INTERNATIONAL CODE COUNCIL

2022 REPORT OF THE COMMITTEE ACTION
HEARINGS ON THE 2021 EDITIONS OF THE
GROUP B INTERNATIONAL CODES

HELD IN ROCHESTER, NY
MARCH 27 – APRIL 5, 2022

FIGURE R602.10.2.2
LOCATION OF BRACED WALL PANELS

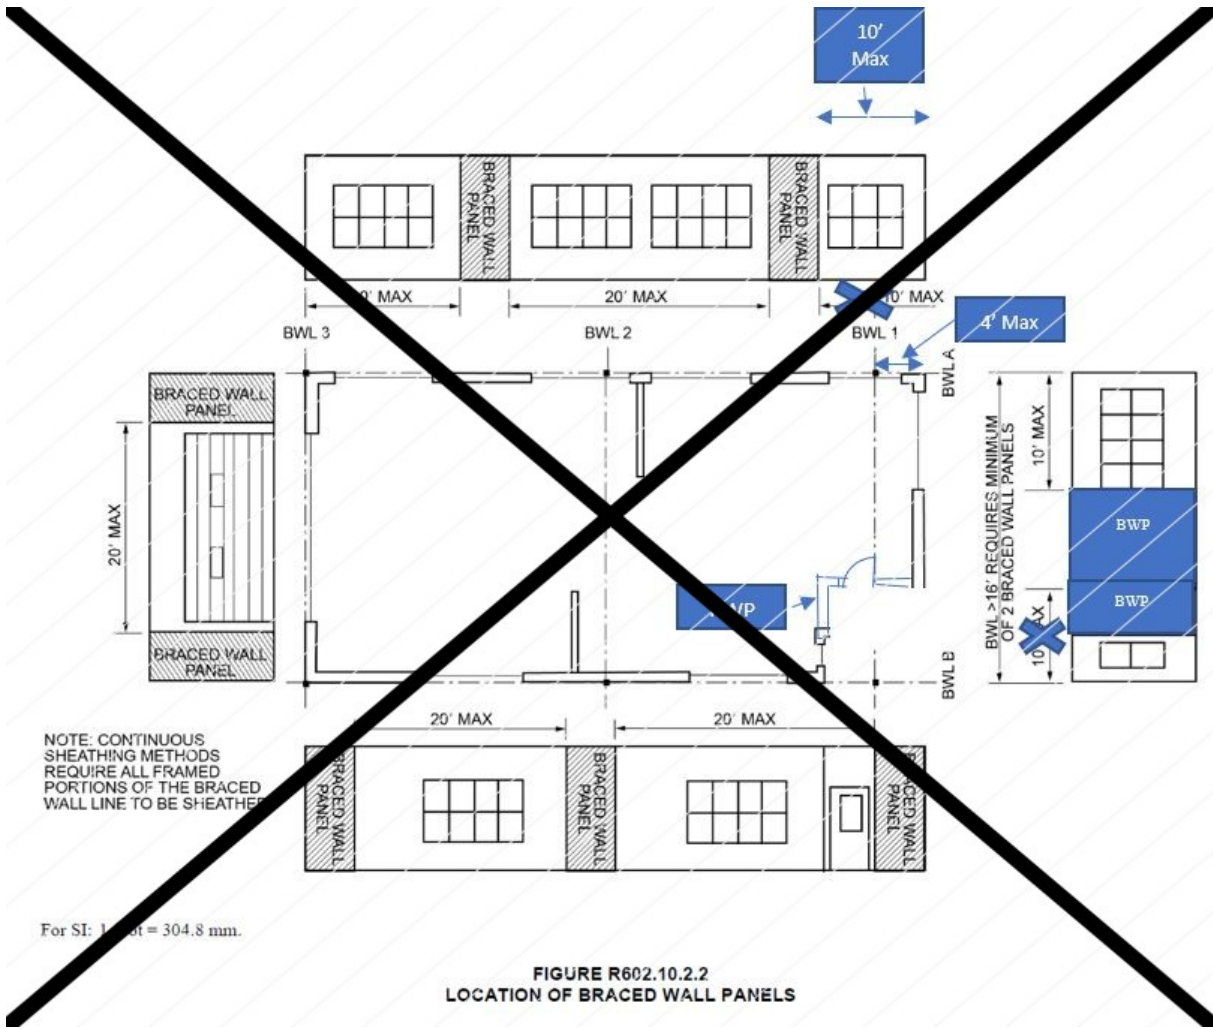
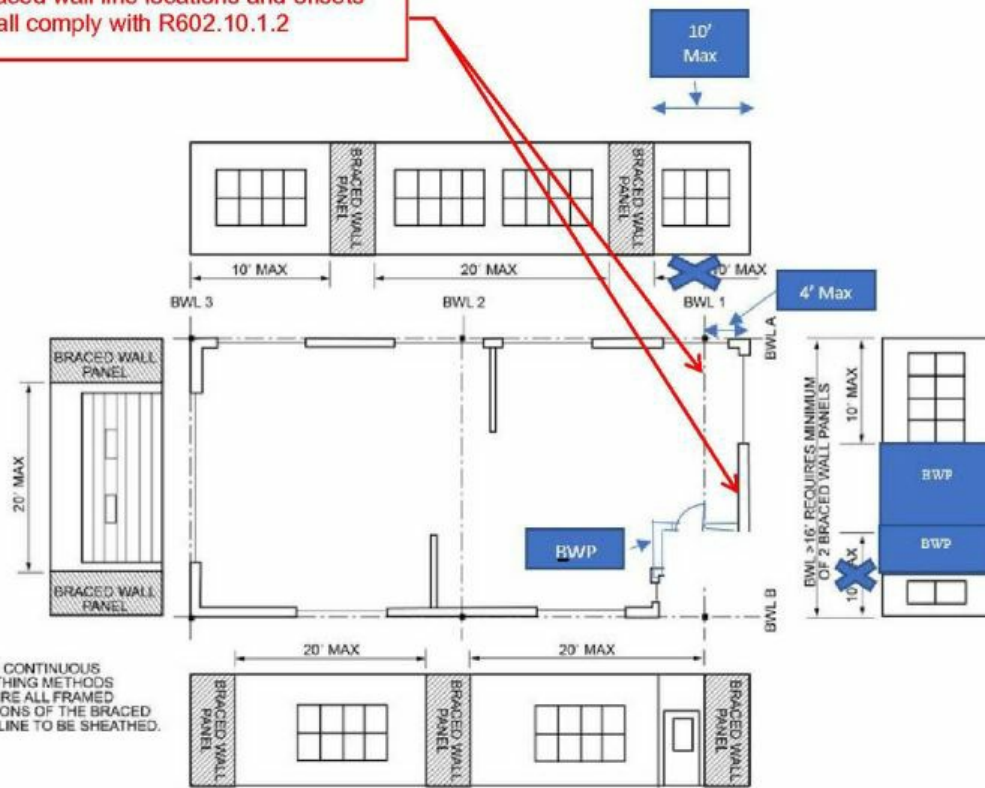
Braced wall line locations and offsets shall comply with R602.10.1.2

Committee Reason: The committee concluded that the modification clarifies the reference of the locations and offsets for braced walls. The committee determined that the proposal as modified fixes the inaccuracies in Figure R602.10.2.2. In addition, The proposal correlates Figure R602.10.2.2 with the change to BWL placement in IRC 2021 Section R602.10.1.2 (Vote: 10-0).

FIGURE R602.10.6.2 METHOD PFH—PORTAL FRAME WITH HOLD-DOWNS

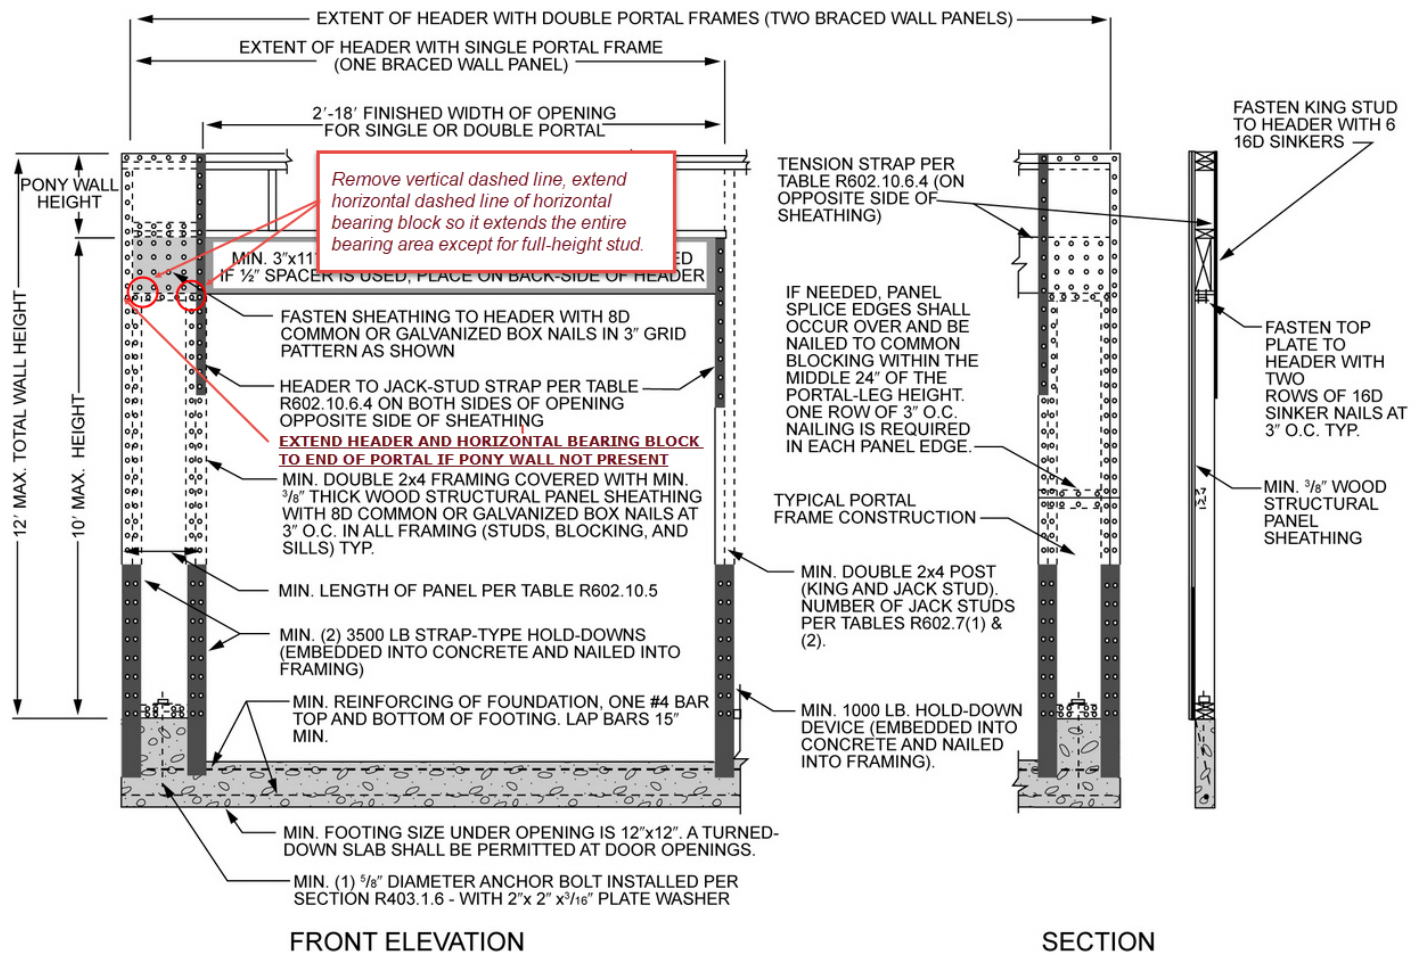
Revise Note in center of portal as follows;

Figure R703.14.1.1.2 (1) Typical Trim Under Window and Top of Walls Polypropylene Siding

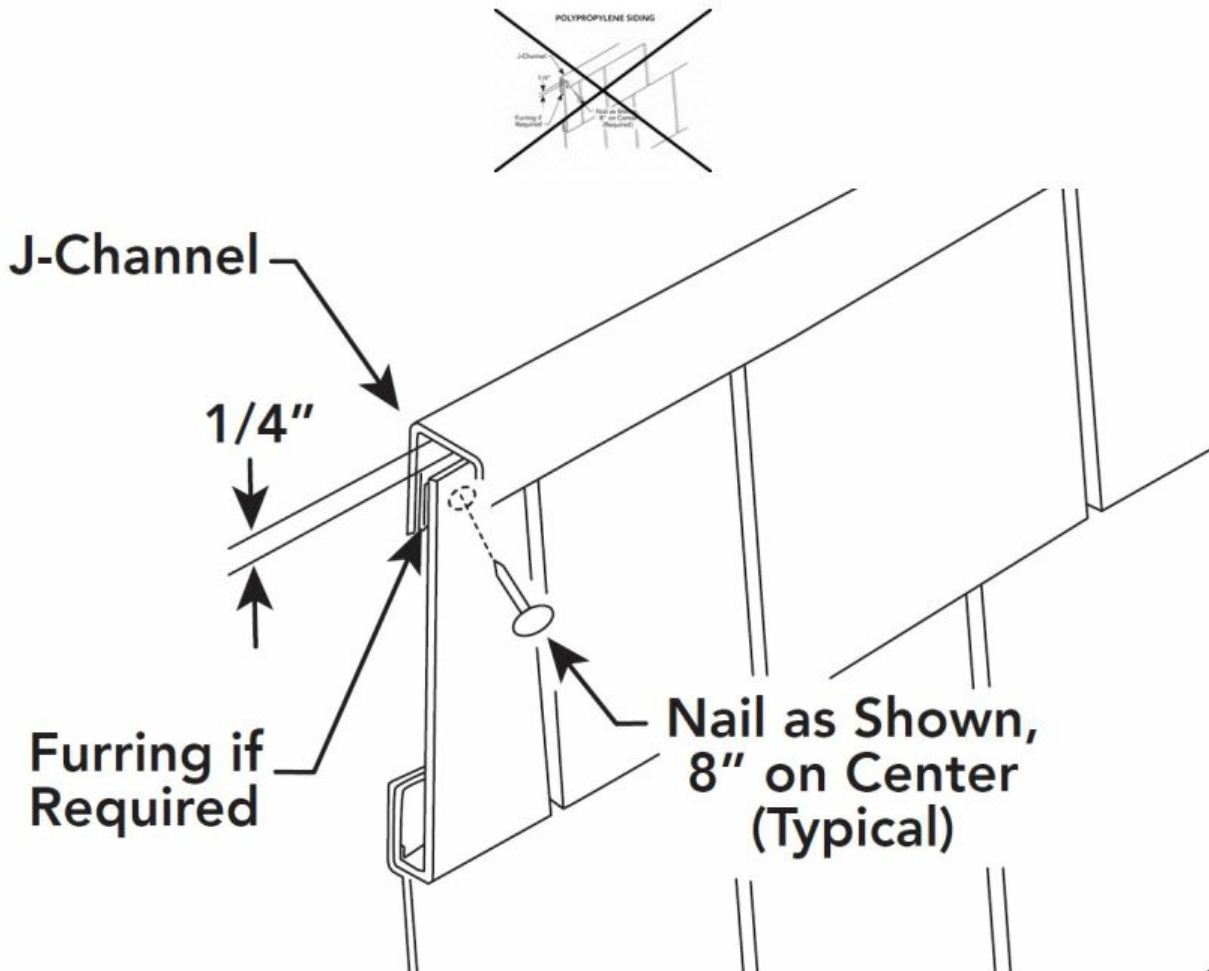
R703.14.1.1.1 Starter Strip. Horizontal siding shall be installed with a starter strip at the initial course at any location. Where installation of a starter strip is not possible other approved equivalent shall be permitted.

Committee Reason: The committee determined that the modification clarifies the requirements and improves the understanding of the figure. The committee decided that the proposal, as modified, provides code guidance for polypropylene siding installation spacing for fasteners. The proposal also references different manufacturers' installation instructions (Vote: 9-1).
